Draft Yarra Ranges Planning Scheme Amendment C193

4 Melba Avenue, Lilydale (Lilydale Quarry)

Date of Statement: 21 May 2021

STATEMENT TO THE STANDING ADVISORY COMMITTEE BY JASON LEE WALSH, TRAFFIC
ENGINEER

Figure 7: Existing Traffic Network Model Extents

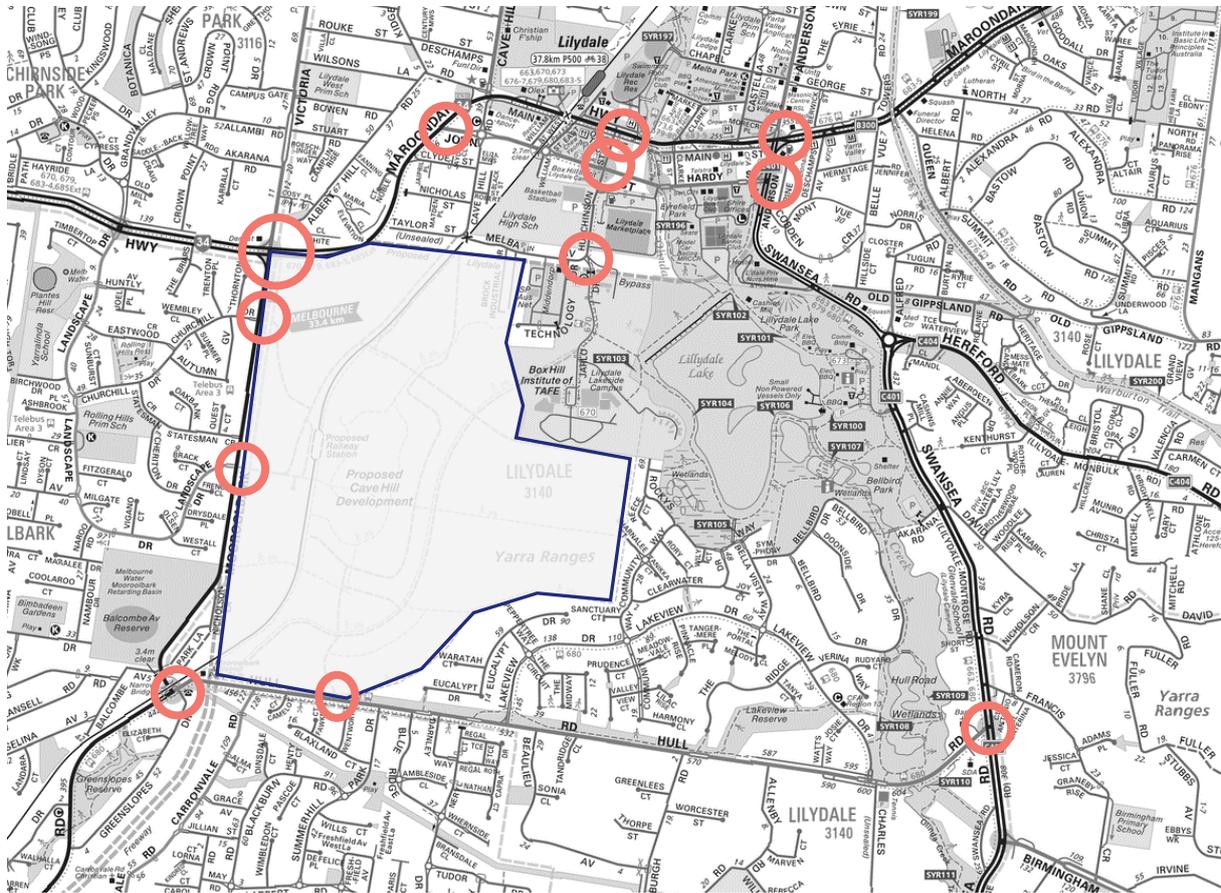
- 84 Cardno adopted a traffic modelling/study area that included the following key intersections surrounding the site as shown in Figure 7.
- a. Maroondah Highway / Victoria Road / Mooroolbark Road.
 - b. Maroondah Highway / John Street.
 - c. Maroondah Highway/ Hutchinson Street.
 - d. Maroondah Highway / Anderson Street.
 - e. Mooroolbark Road / Churchill Drive.
 - f. Mooroolbark Road / Landscape Drive.
 - g. Mooroolbark Road/Hull Road.
 - h. John Street / Hutchinson Street.
 - i. Hutchinson Street / Melba Avenue.
 - j. Hardy Street / Anderson Street.
 - k. Hull Road / Swansea Road.
 - l. Hull Road/Honour Avenue (new intersection to Stage 1 of Kinley).
- 85 I am comfortable this is an appropriate extent of the model and that the inclusion of further intersections surrounding the site, or within the model area, is not necessary.
